Development Application 200601605

Address: 1 Hill Corner Yarralumla ACT 2600
Location: Section 62, Block 2
Proposal: NONR - Institutional - Pre School - Construction of a new single storey Pre School - Lease Variation.

Photographs of parking outside the preschool at Hill Corner, March 2007

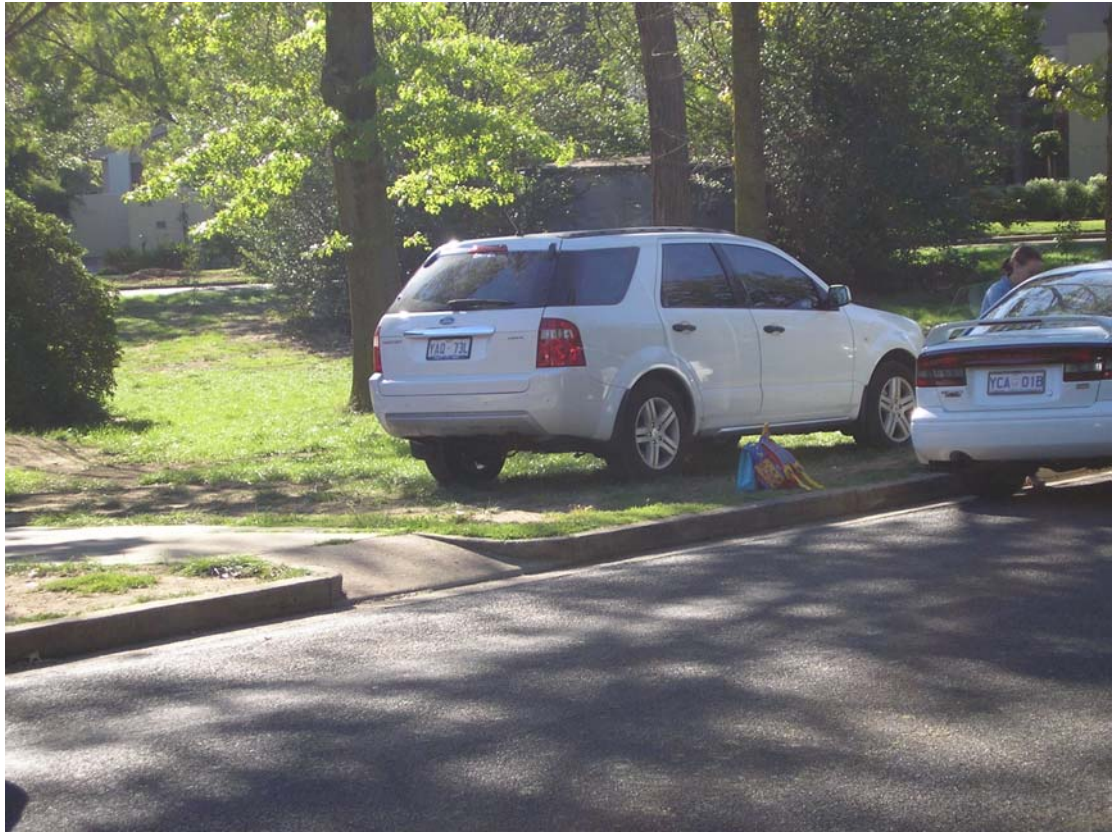
Parents and teachers have already expressed their concerns to residents about the safety of the child set-down and pick-up arrangements. They have explained that they take the liberty of mounting the kerb in their large 4WD vehicles to park on the Nature Strip and in the Hill Corner Park because they consider it too congested and unsafe to set down and pick up their children at the kerb³. The current risks to 18 students should be remedied by on-site parking, and not aggravated by increasing the size of the problem by more than doubling the number of student places. The high risk use of on-street parking is in contrast to purpose built government preschools which make much better provision for safe parking.

Parking in Hill Corner Park to set down children safely in spite of available street parking – note emerging wheel ruts in foreground.

Using Hill Corner Park for safe and convenient parking by 4WD driver

Mounting the kerb to set down children safely in spite of street parking places being available
